**SMYRNA SCHOOL DISTRICT
John Bassett Moore Intermediate School
Bid Number SSD-15-002**

ADDENDUM NO. 1

21 April 2015

ARCHITECT'S PROJECT NO: 14107b

DECK INFILL DTL

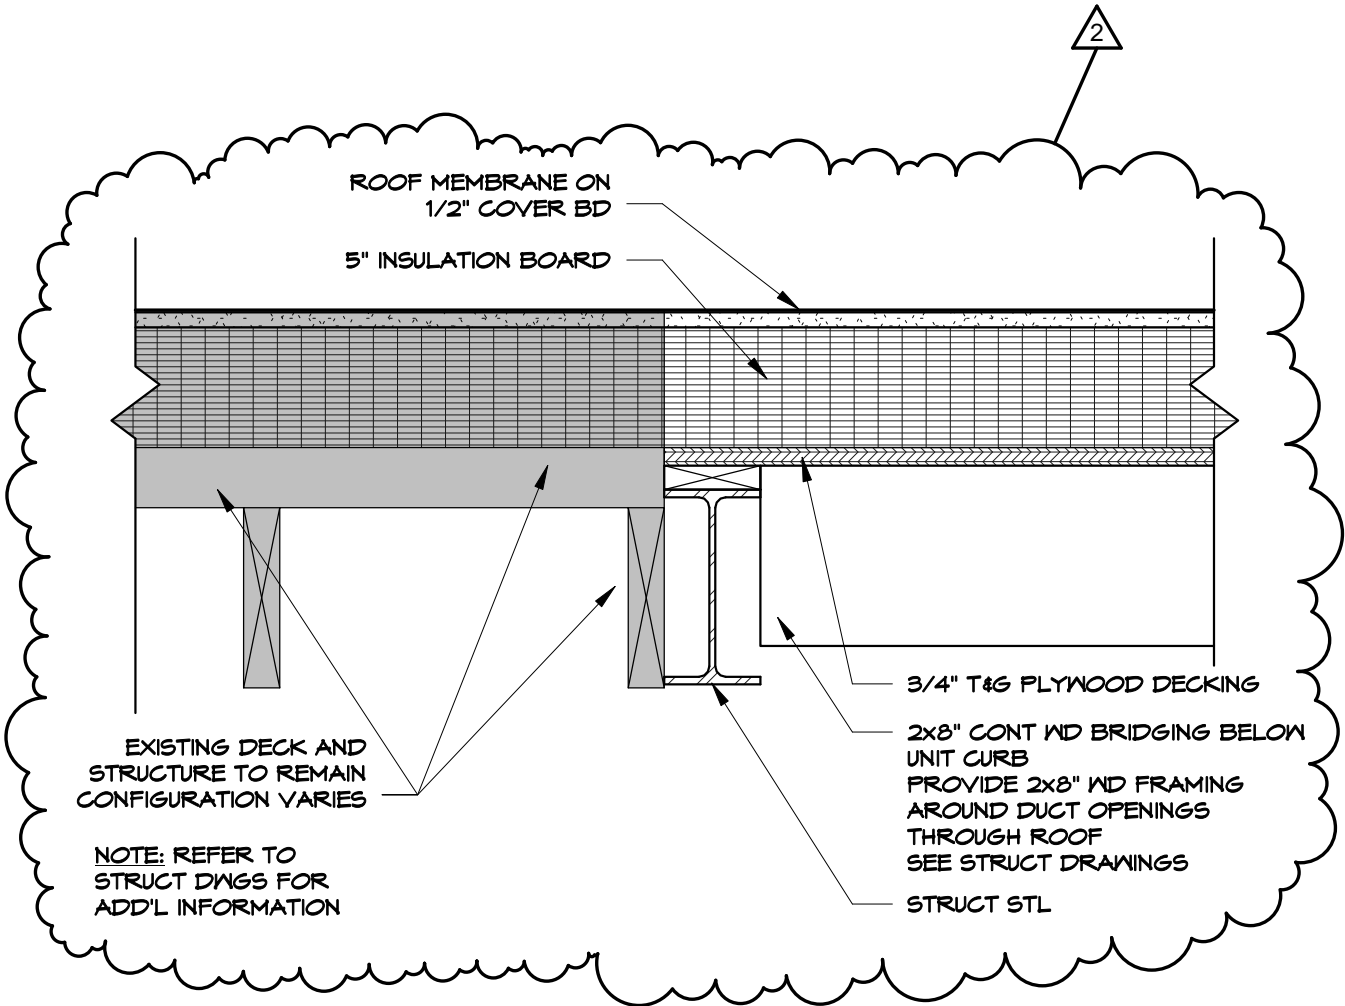
- 4.1 Detail 6/A10-02 – Revise mechanical unit demolition notes to coordinate with mechanical clarifications to Sheet MD102 mentioned above.
- 4.2 Detail 9/A10-03 – Remove note indicating drainage board.
- 4.3 Detail 6/A10-03 – T.O.M. elevation provided at 8'-8", relative to 37.76 elevation on civil drawings.
- 4.4 Sketch: A-SK-001 Sketch revises Detail 1/A34-01
